# A G E N D A

## Architectural Review Board

December 15, 2021 – 5:30 p.m.

The rafter is 16" on center  
 The roof pitch is 8'/12"

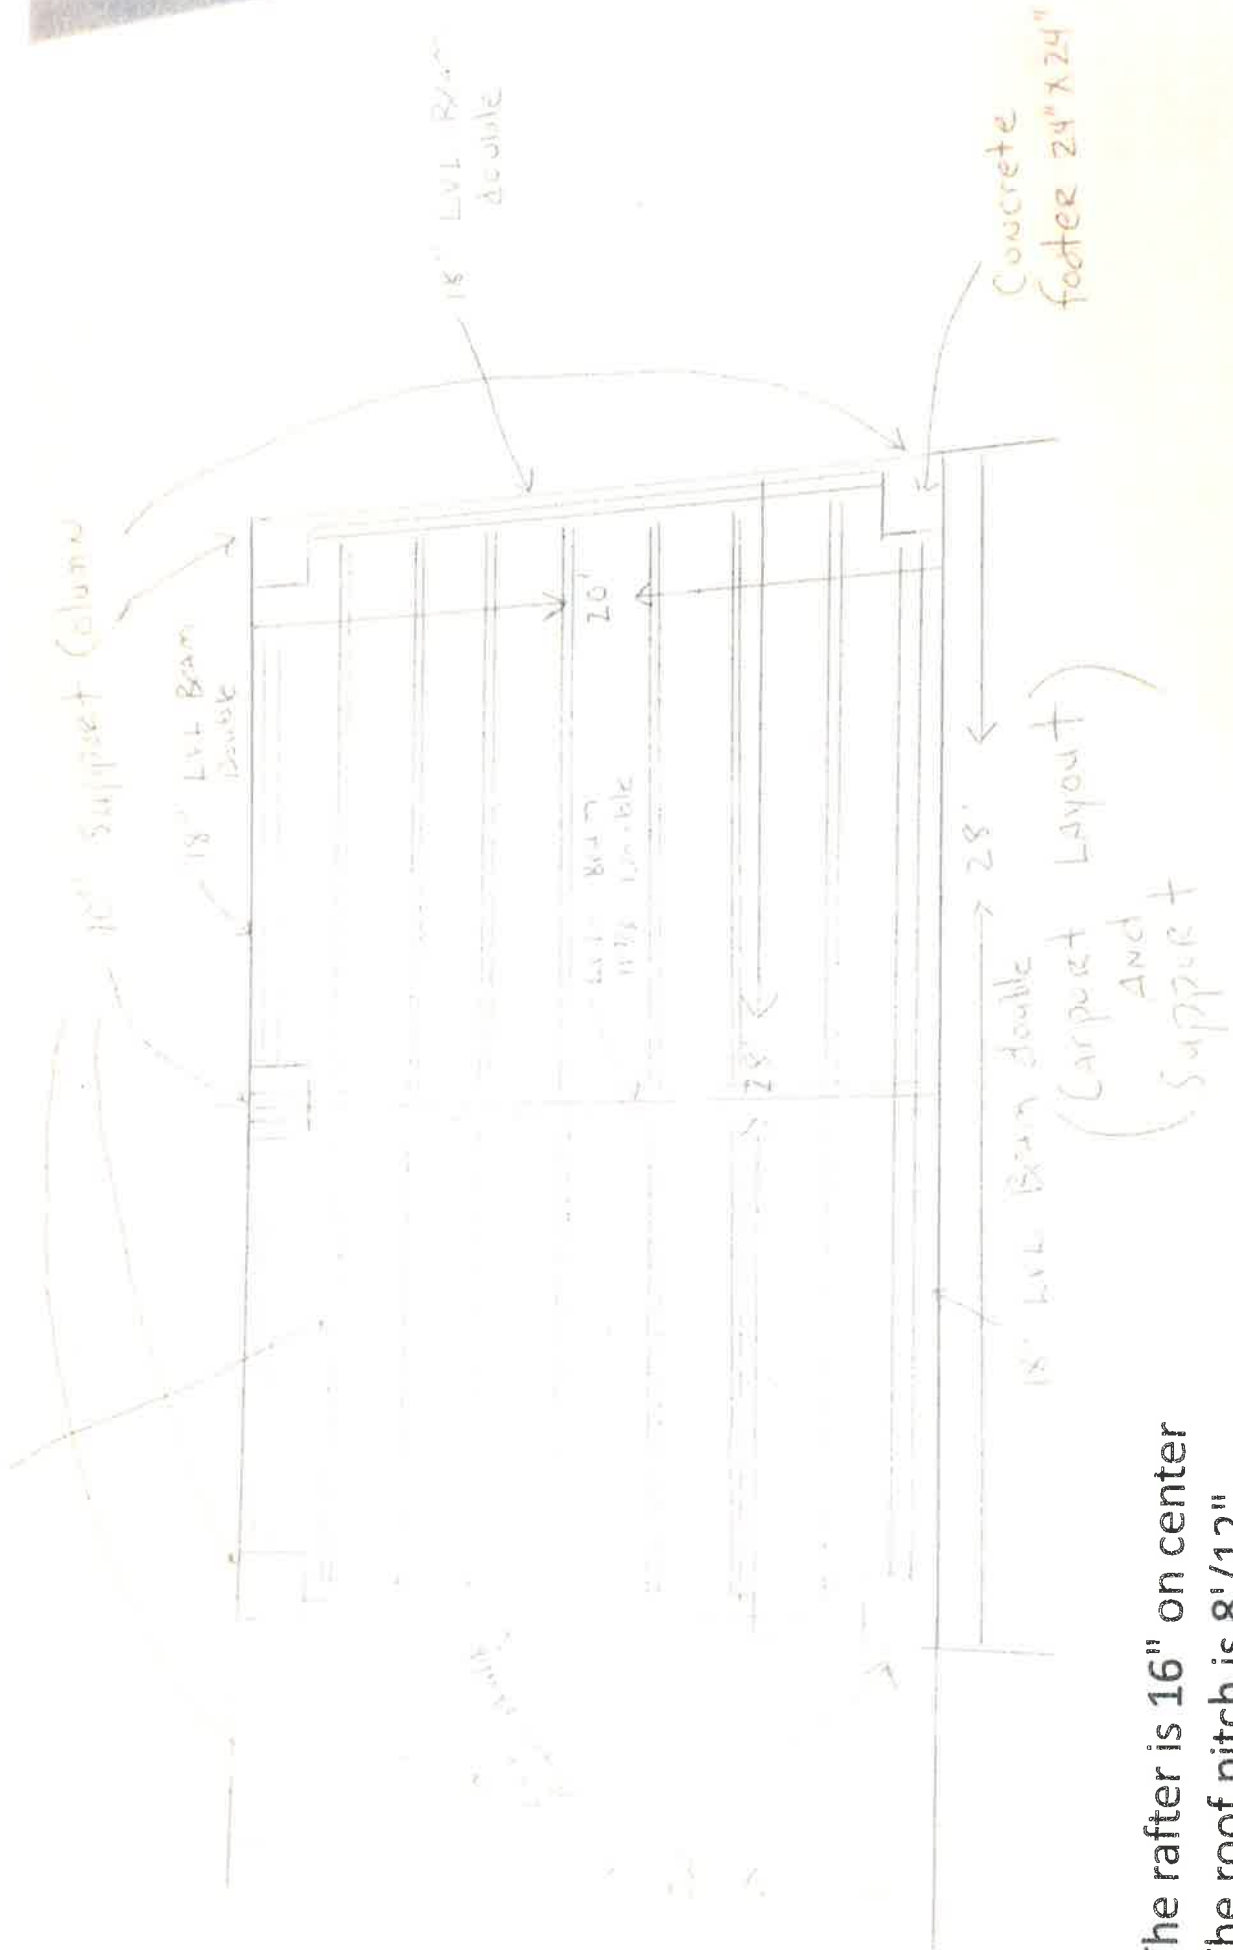
- This is similar to one previously approved on Felder Avenue in Cloverdale. No objection.

Pictures of Different Windows  
in sub Div.

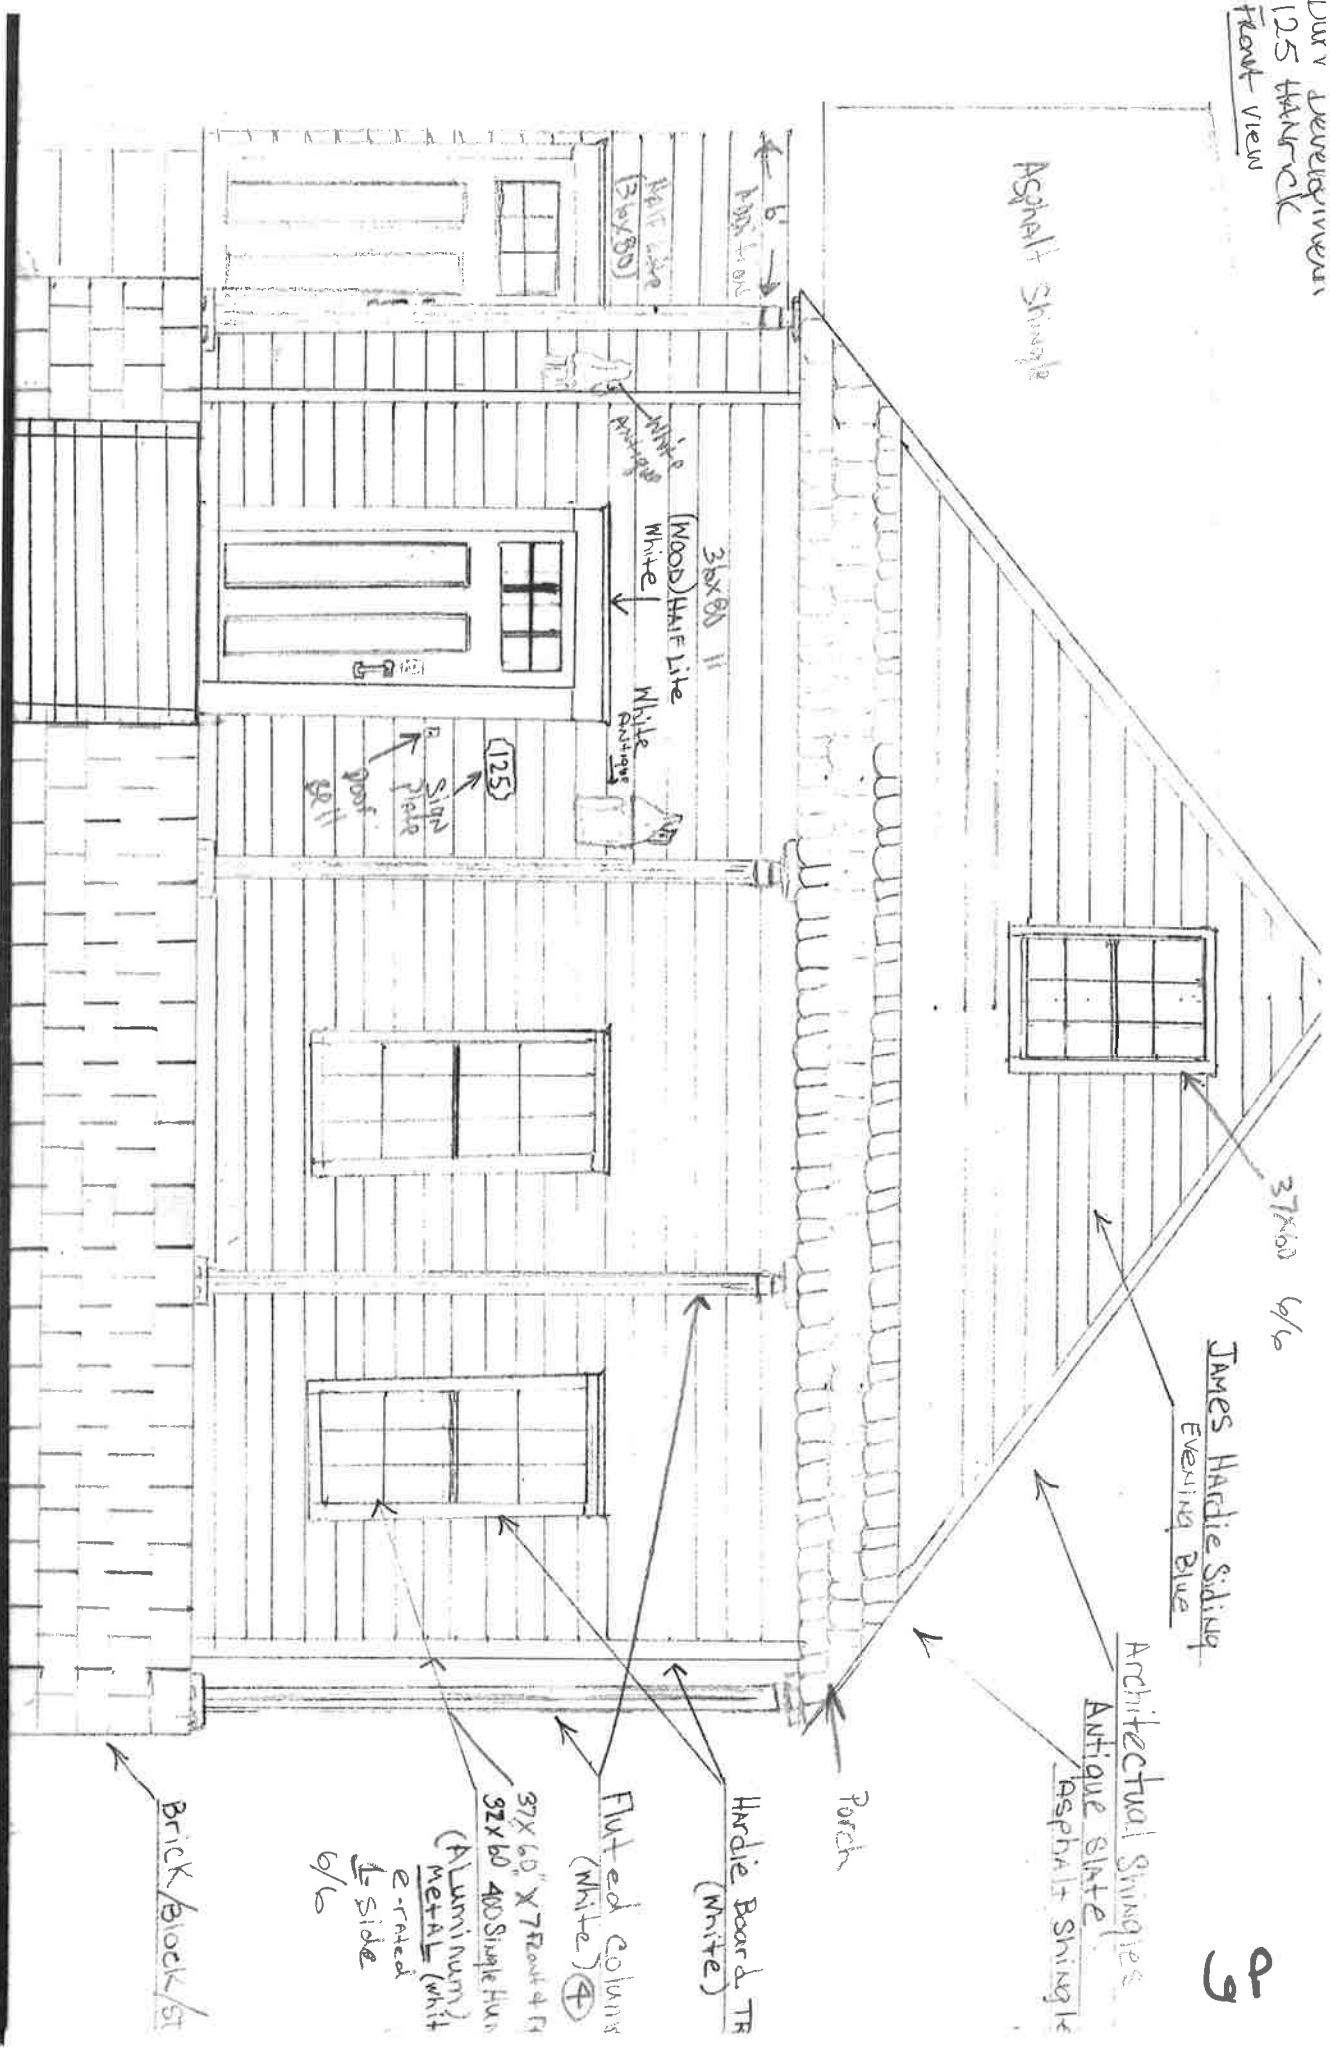
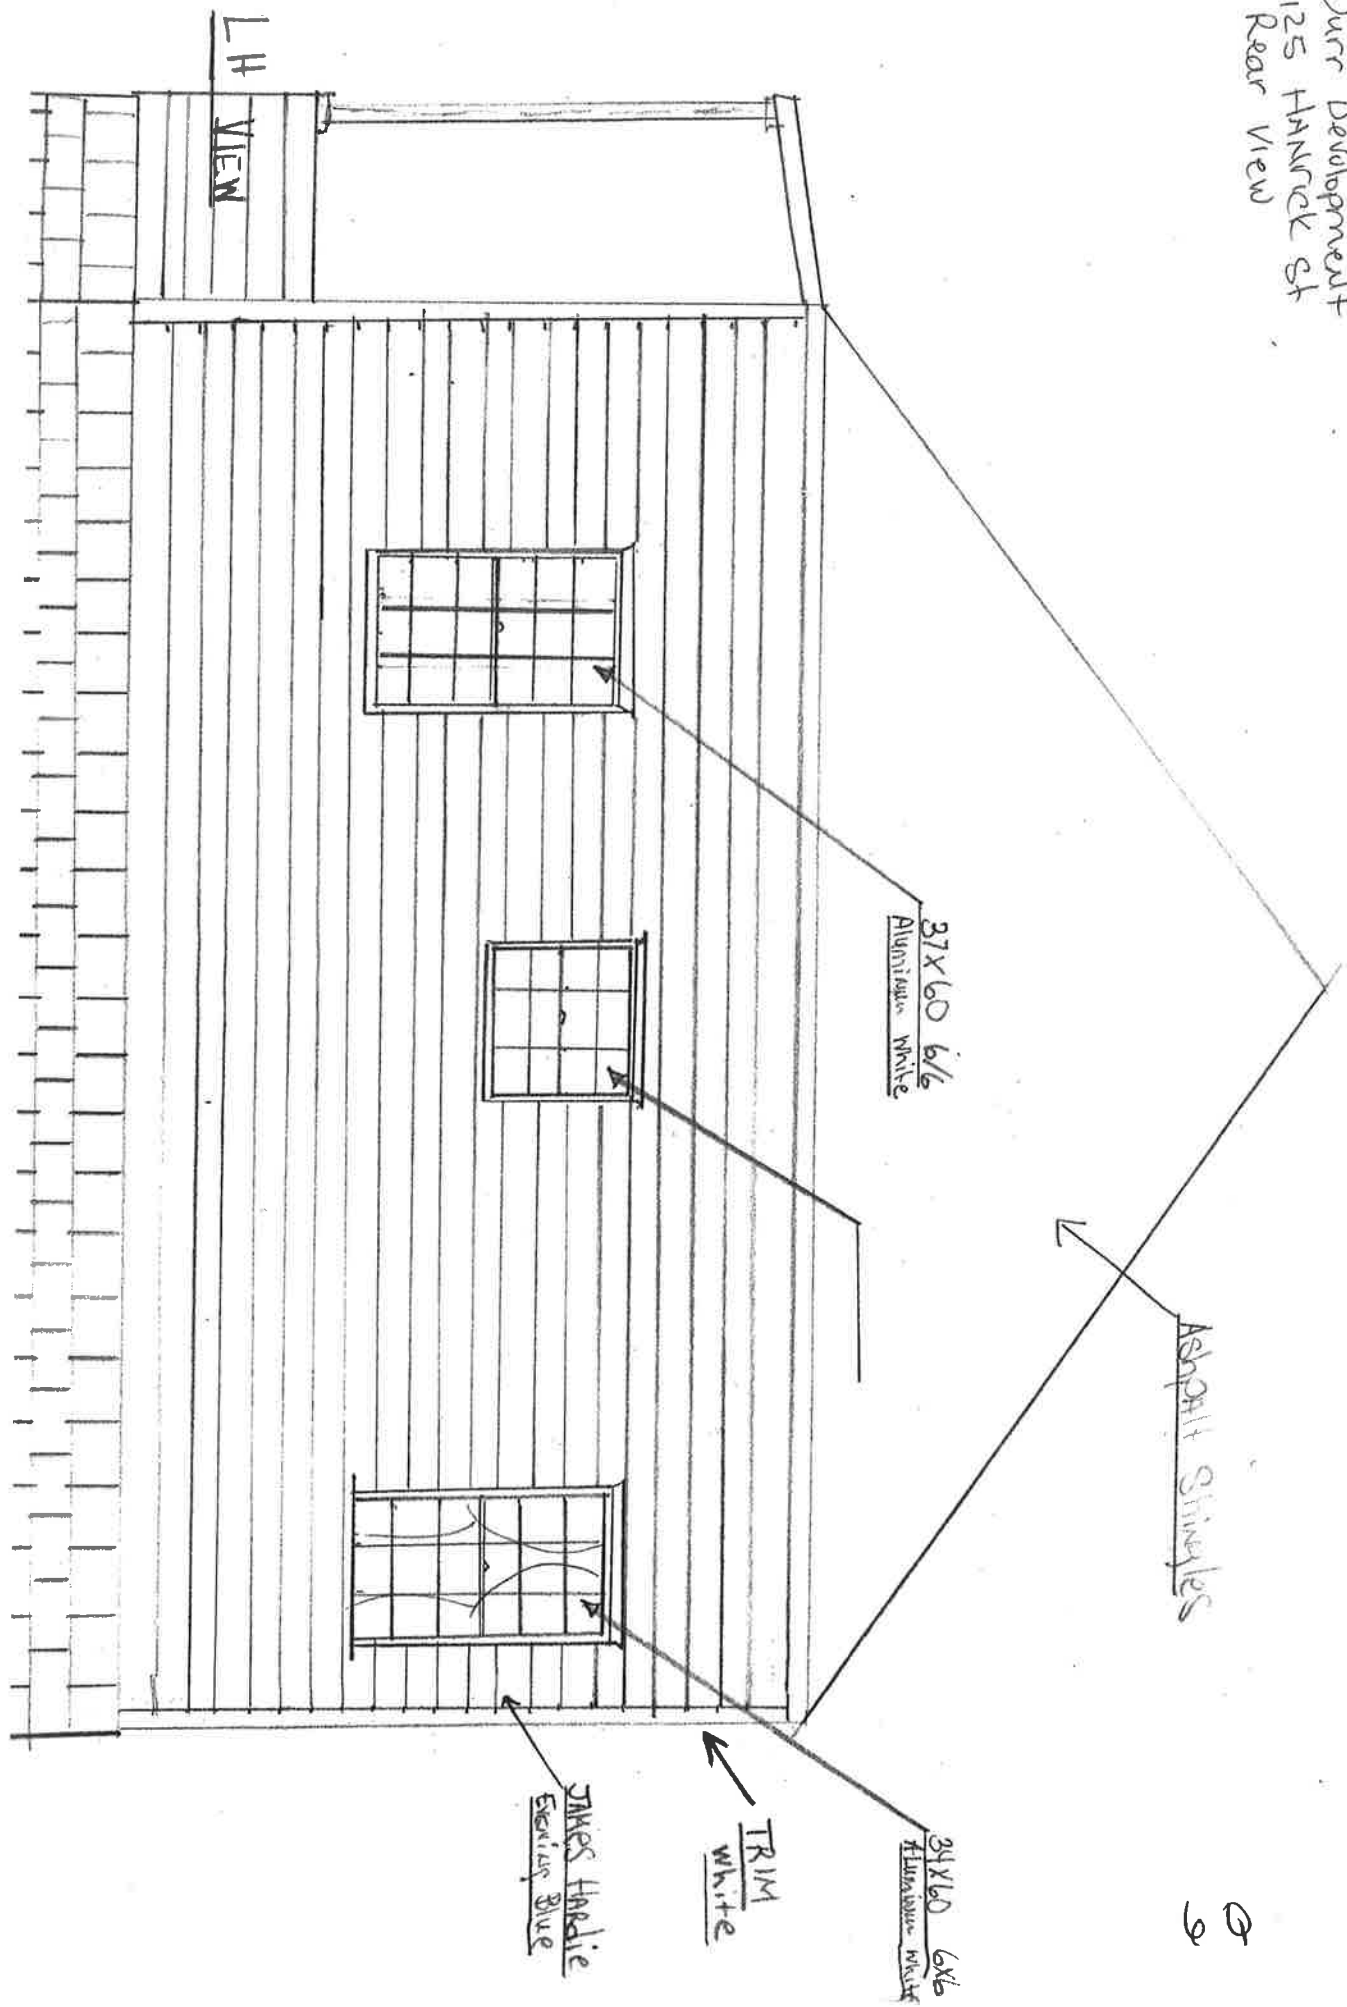
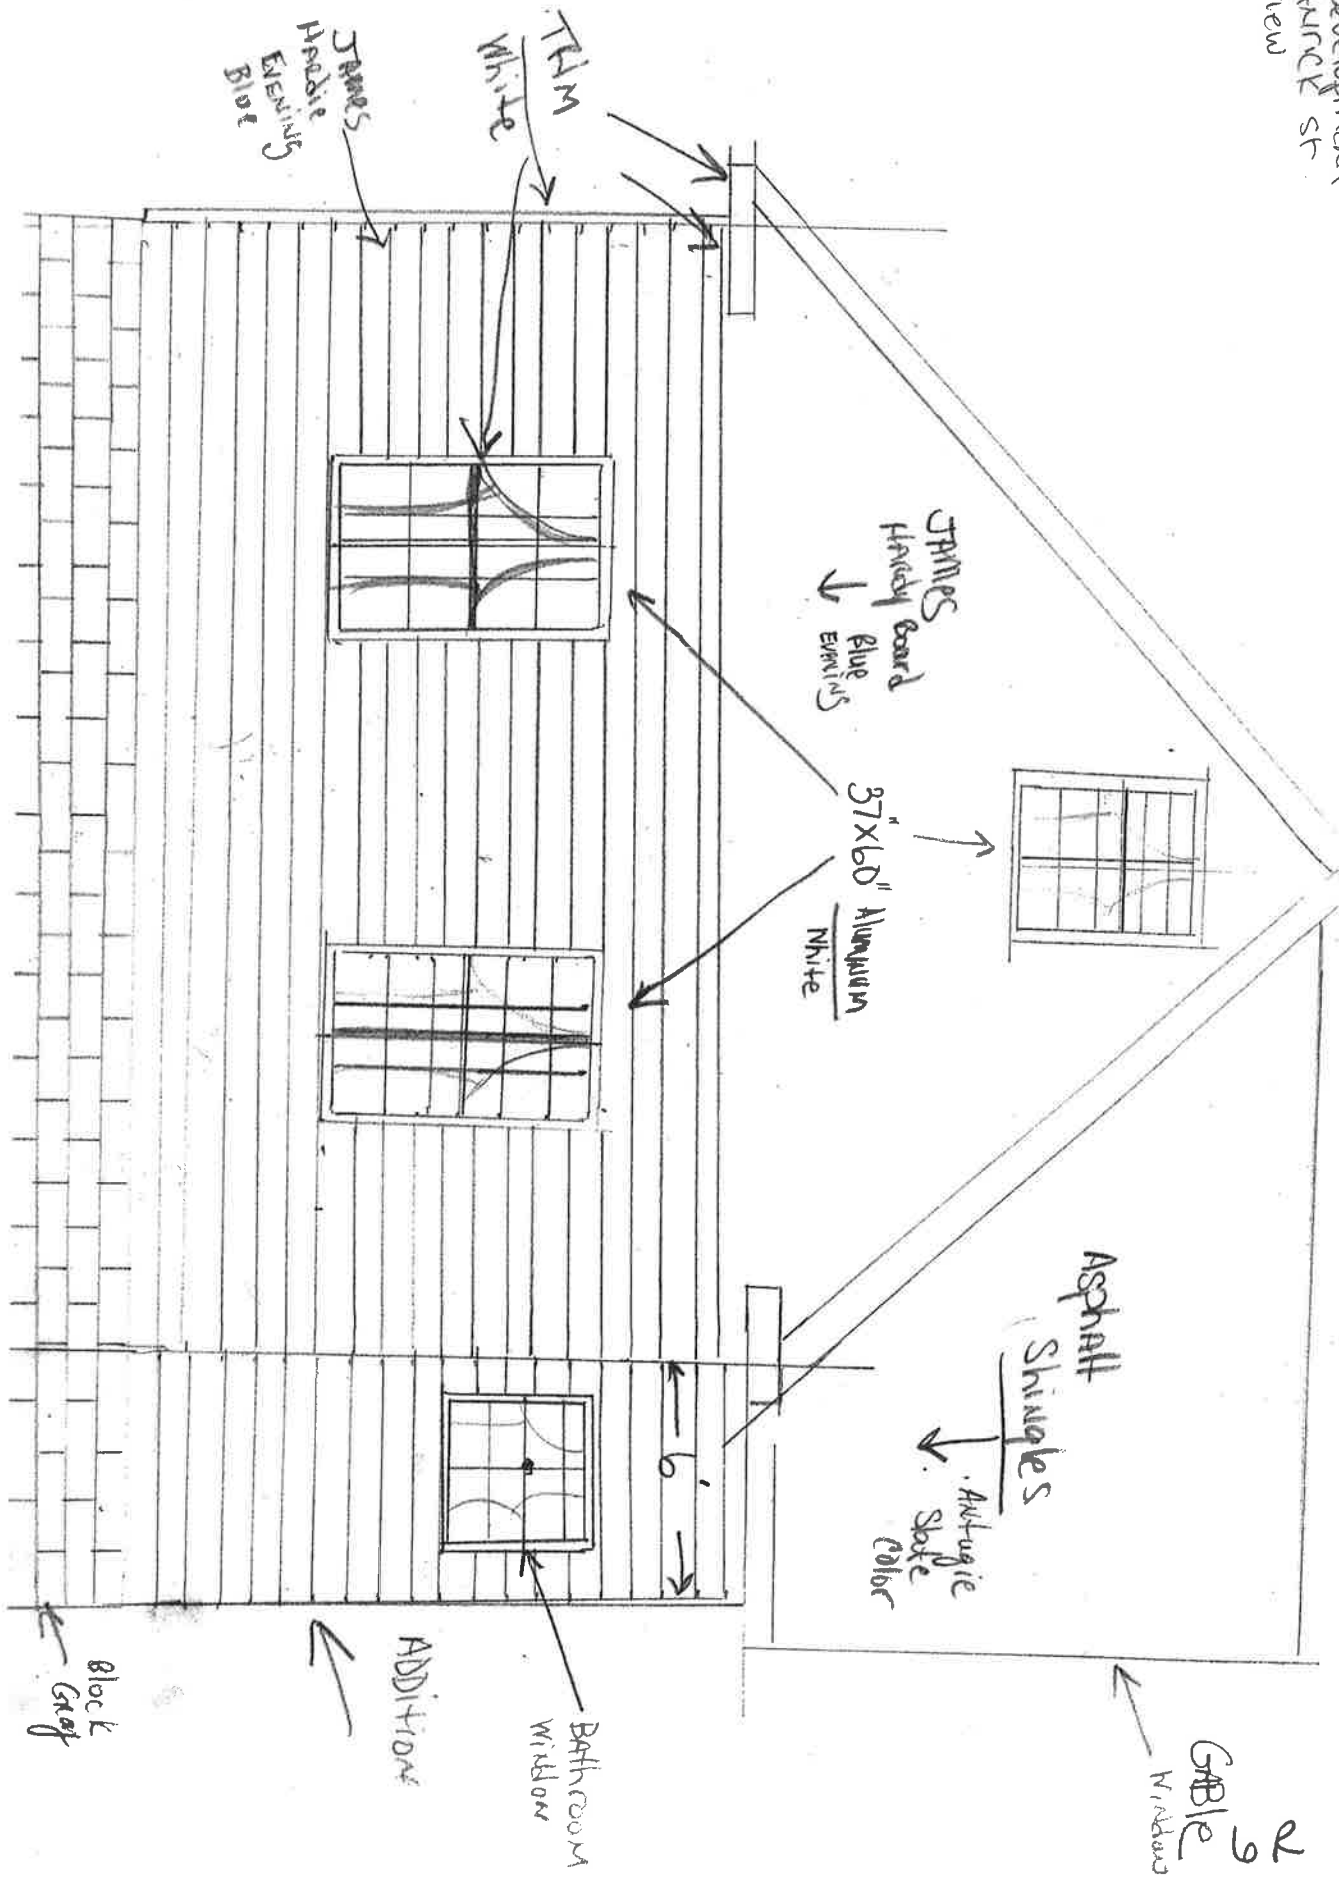
- Shortening the window height on a house with a steep roof pitch that draws the eye upward makes the windows appear squatty.
- The Board has consistently required replacement windows to match the historic windows in size and configuration. A window has been added on the front porch, and the attic windows reduced in size and number from the previously approved plan.

- Metal windows have not been approved for residential properties, and have only been considered where metal windows have already been present. The original windows in this house were 2/2.

- Door and window trim width has not been specified and should be. Standard width of most historic trim is 6" and window openings also include a drip cap—a brick mold or 4" Hardie trim will not be sufficient to emulate the historic detail.

- The Board needs to consider if the craftsman style door is appropriate for a turn of the century house.
- The Board needs to determine if the columns are an appropriate style and scale.

- There is no mention of a porch rail. Approval would be required to install one.
